RE: Proposed Revisions to *ENERGY STAR*[®] Program Requirements

The **Skylight Council** of the American **Architectural Manufacturers Association** (AAMA) appreciates the opportunity to provide additional comments and suggestions related to the most recent proposed revisions to the *ENERGY STAR*[®] Program for fenestration products as presented in the *Windows, Doors, and Skylights Draft Criteria and Analysis*, ('Draft Analysis') dated August 6, 2008.¹

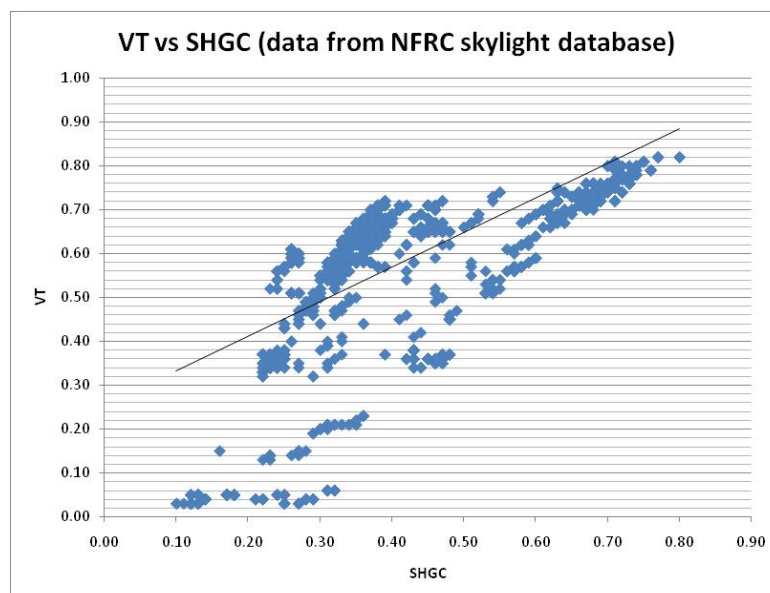
5. **Visible Transmission Considerations.** The following graph displays Visible Transmission data taken from NFRC’s CPD for skylights and plots it versus the Solar Heat Gain coefficient:

The proposed *ENERGY STAR*[®] criteria changes do not address the general lighting power density in an interior space. For adequate lighting, the general power density should be between 5 W/m² and 14 W/m². Reducing SHG coefficients will also reduce general lighting power density to the point that skylights will be ineffective at providing an adequate level of lighting without the use of electric illumination.

This could in turn lead to the absurd situation of having to turn on lights during the daytime in an interior space due to insufficient illumination being provided by the skylights. Continued lowering of SHG coefficients could eventually lead to serious hardship in the skylight industry itself, as it would make absolutely no sense to install a skylight if insufficient light is being provided. Daylight efficacy should be reflected in *ENERGY STAR*[®] performance criteria for skylights. Since current NFRC test procedures preclude the availability of certified VT ratings on many popular glazing options used in our members' skylights and tubular daylighting devices, additional evaluation methods need to be developed to test these products.
